Glen Helen Association
405 Corry Street, Yellow Springs, OH 45387

DATE: 26 February 2024
RE: Bid for Parking Lots & Raptor Center Improvements
BID DATE: 01 March 2024

BID ADDENDUM #3

Plates and Pole Guards

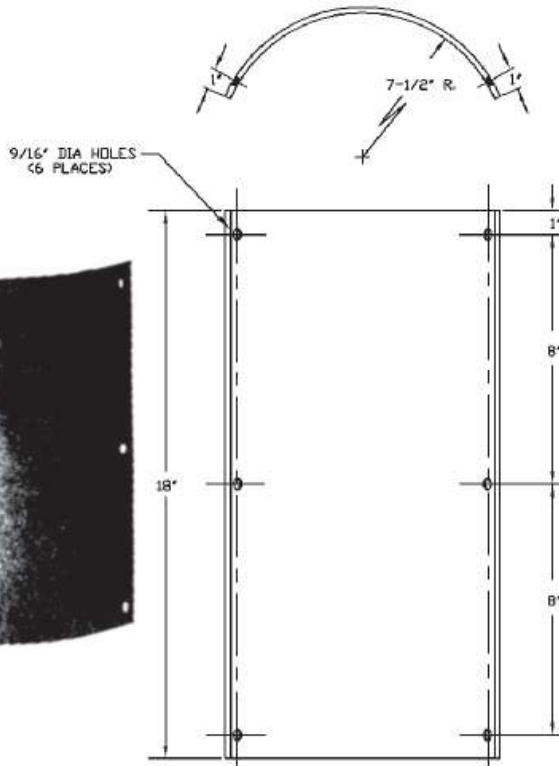
Question 2: a) On the 'General Notes' of the Corry St. Lot Plans, the 'PIPE BOLLARD DETAILS' scales differently than indicated in the included measurements. We would like clarification on this feature. b) Corry Street Lot "Pole Guards" - These are stated in the plans. Please specify what these are exactly.

Response: Please Refer to the drawings for pipe bollard locations. The attached Bollard detail is for reference on footing depth and height of bollard, color, etc.
